## FOR PERCOLATION TESTING AND SITE EVALUATION

RE: **Percolation Test Results, Mooresfield, Lot 7; 11721 Wayneridge Street**

3. GRADING, EROSION AND SEDIMENT CONTROL PLAN  
Percolation Certification Plan  
11721 Wayneridge St.  
TAX. MAP 41, PARCEL 293  
MOORESFIELD SUB. Lot 7  
ELECTION DISTRICT  
SCALE 1" = 60'  
HOWARD COUNTY, MARYLAND  
AUGUST 08

RE: **Percolation Certification Plan issues, Mooresfield, Lot 7; 11721 Wayneridge Street**

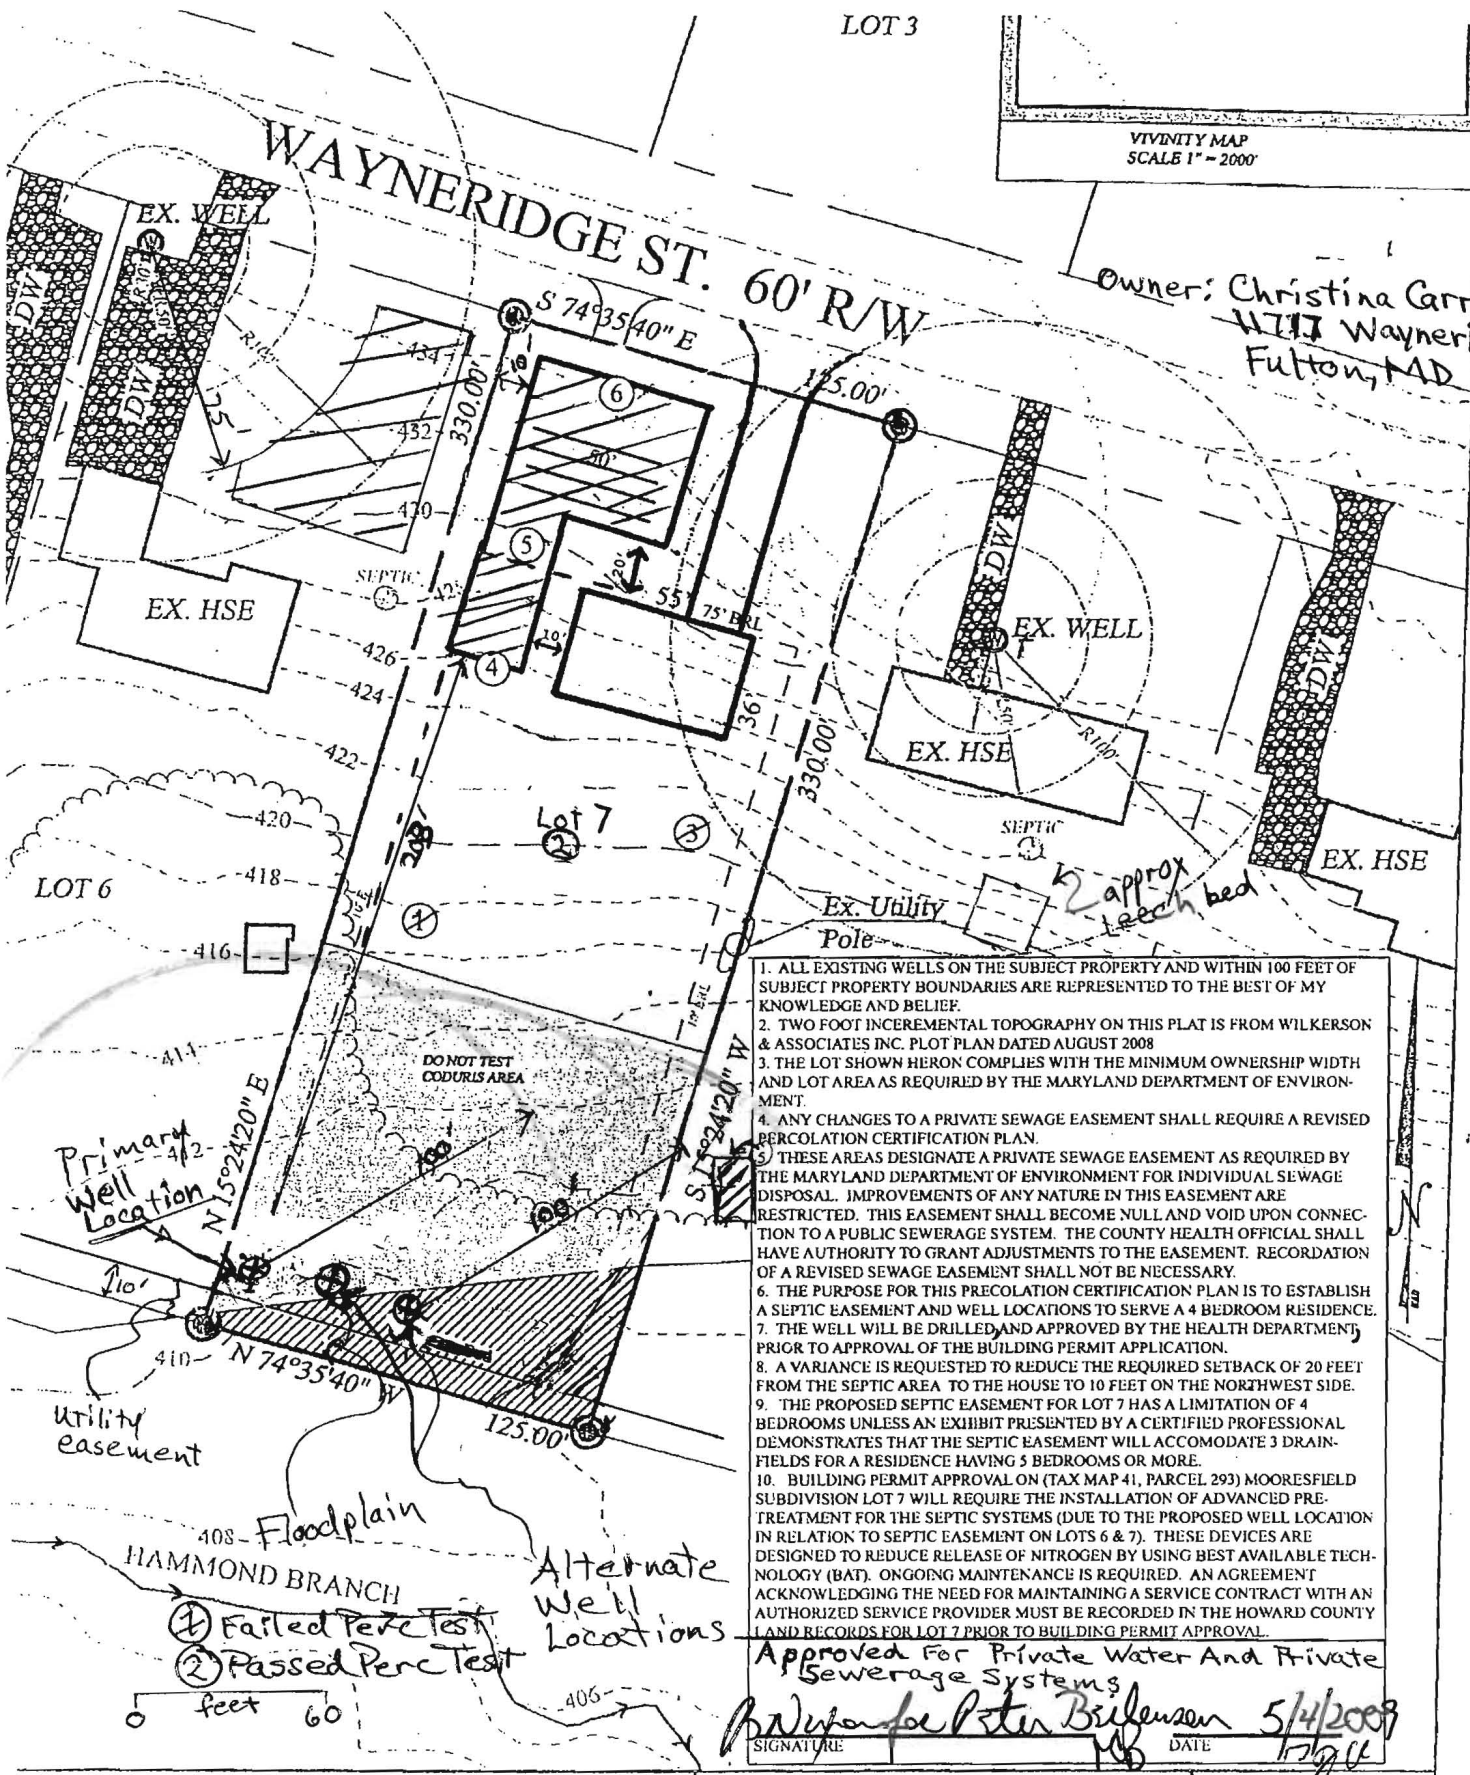
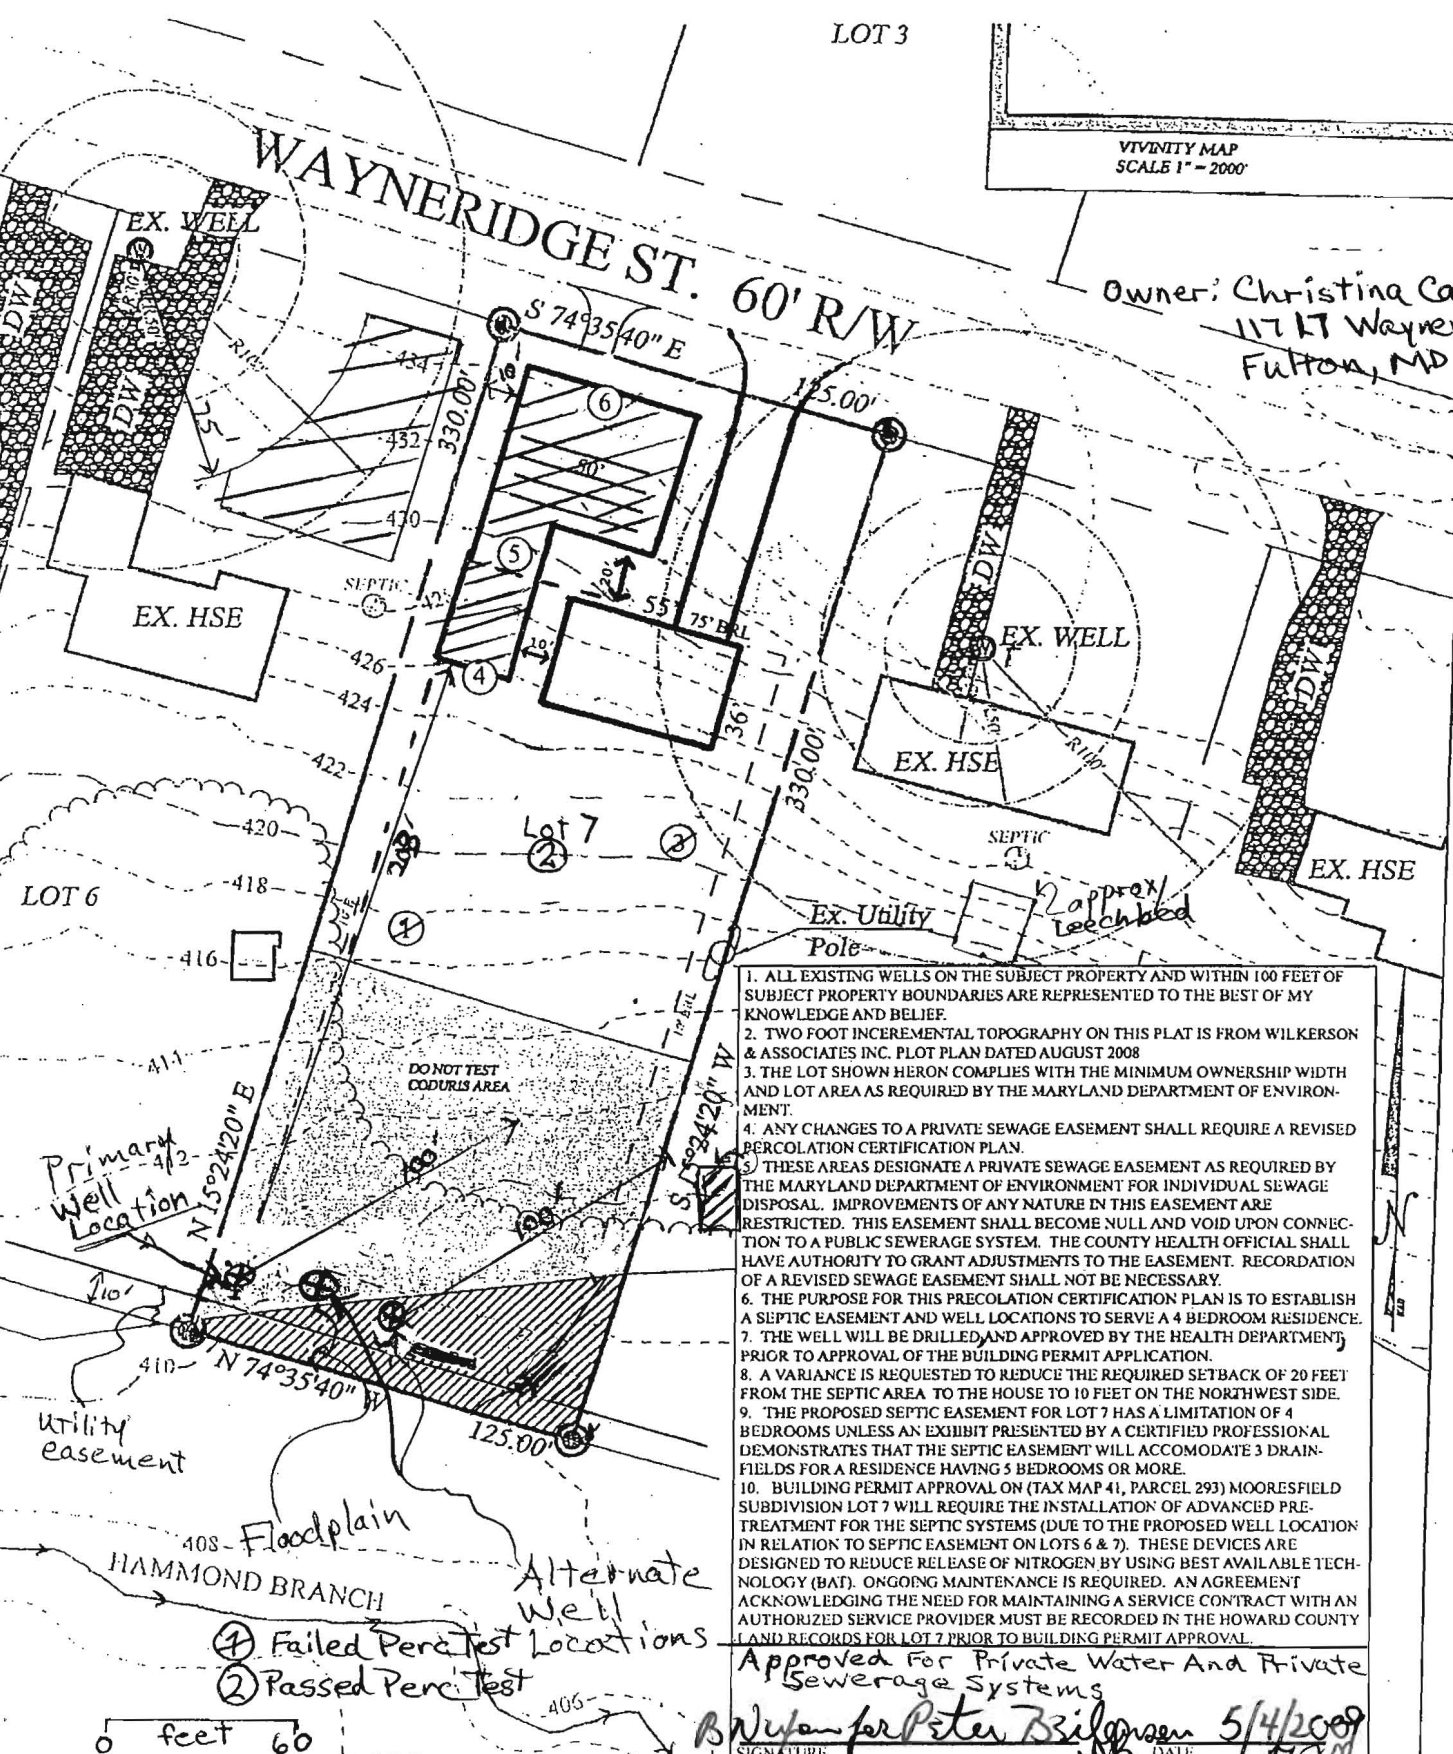
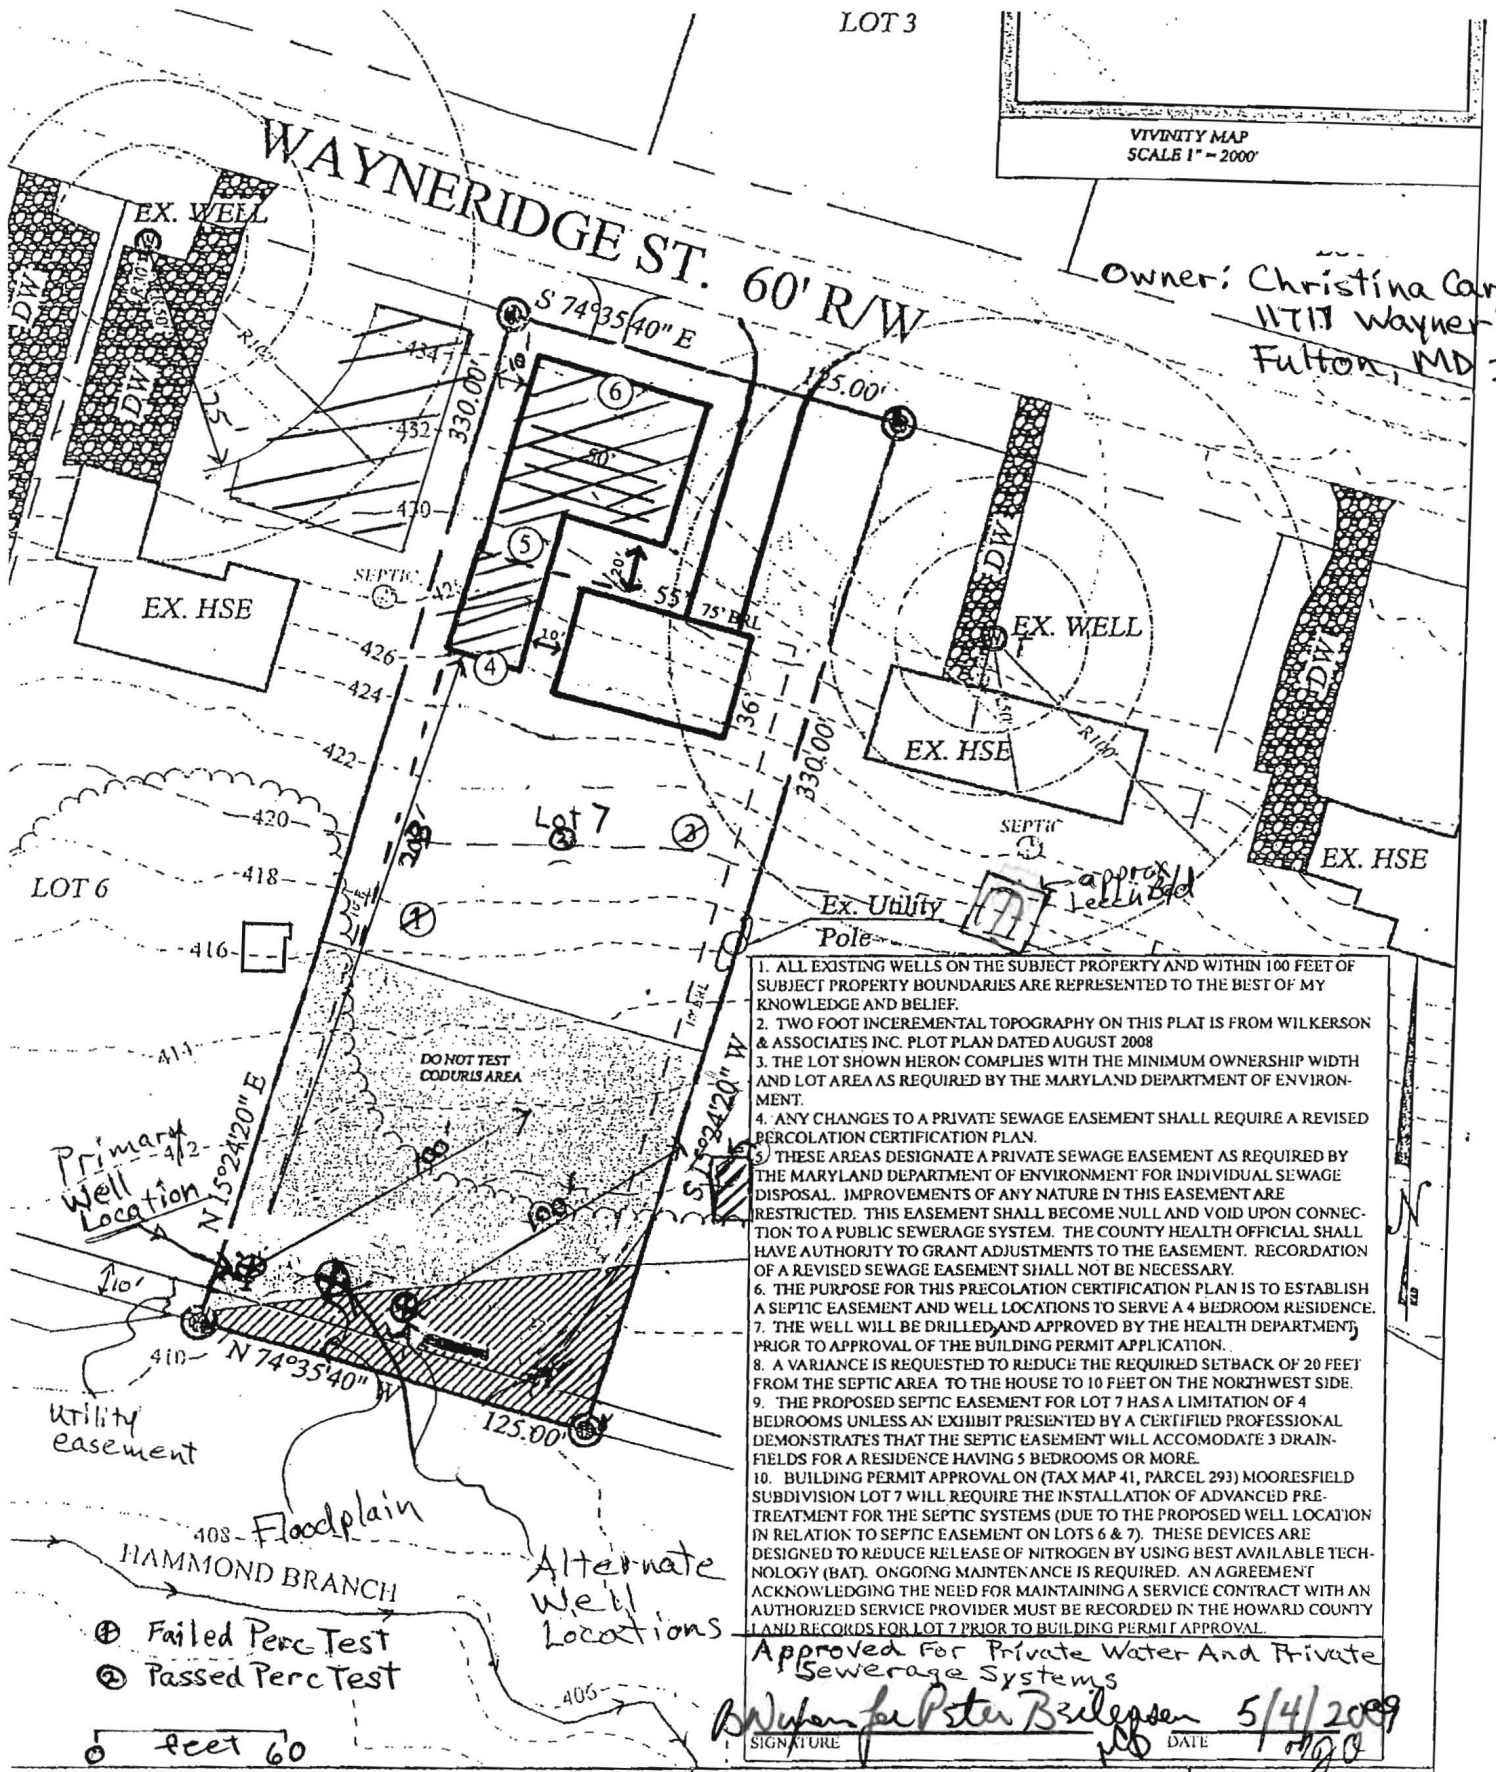
Enclosed are the perc test results and sketch from February 9. I have also marked-up a copy of the previously proposed Perc Cert. Changes such as location of Ms. Carr's well, proposed well locations on Lot 7, approvable area for a proposed septic easement on lot 7 (in relation to previously proposed structure), perc test #6, and the utility easement at the back of Lot 7. These changes must be incorporated on a new drawing along with any changes concerning the proposed residence. The Percolation Certification Plan needs to be presented on a 11" x 17" sheet. There is far too much information required to try to fit on an 8.5" x 11". Incorporate the following amendments in the Notes:

1. In Note 8, insert the phrase ... "on the northwest side" (of the house to 10 feet).
2. Note 9 should be worded as follows

3. Note 10 needs to be worded as follows

3. Use a Legend if necessary to keep the drawing from becoming too cluttered.

THE PROPOSED SEPTIC EASEMENT FOR LOT 7 HAS A LIMITATION OF 4-BEDROOMS UNLESS AN EXHIBIT PRESENTED BY A CERTIFIED PROFESSIONAL DEMONSTRATES THAT THE SEPTIC EASEMENT WILL ACCOMMODATE 3 DRAINFIELDS FOR A RESIDENCE HAVING 5 BEDROOMS OR MORE.

BUILDING PERMIT APPROVAL ON (TAX MAP 41, PARCEL 293) MOORESFIELD SUBDIVISION, LOT 7 WILL REQUIRE THE INSTALLATION OF ADVANCED PRETREATMENT FOR THE SEPTIC SYSTEMS (DUE TO THE PROPOSED WELL LOCATION IN RELATION TO SEPTIC EASEMENTS ON LOTS 6 AND 7). THESE DEVICES ARE DESIGNED TO REDUCE RELEASE OF NITROGEN BY USING BEST AVAILABLE TECHNOLOGY (BAT). ON-GOING MAINTENANCE IS REQUIRED. AN AGREEMENT ACKNOWLEDGING THE NEED FOR MAINTAINING A SERVICE CONTRACT WITH AN AUTHORIZED SERVICE PROVIDER MUST BE RECORDED IN THE HOWARD COUNTY LAND RECORDS FOR LOT 7 PRIOR TO BUILDING PERMIT APPROVAL.
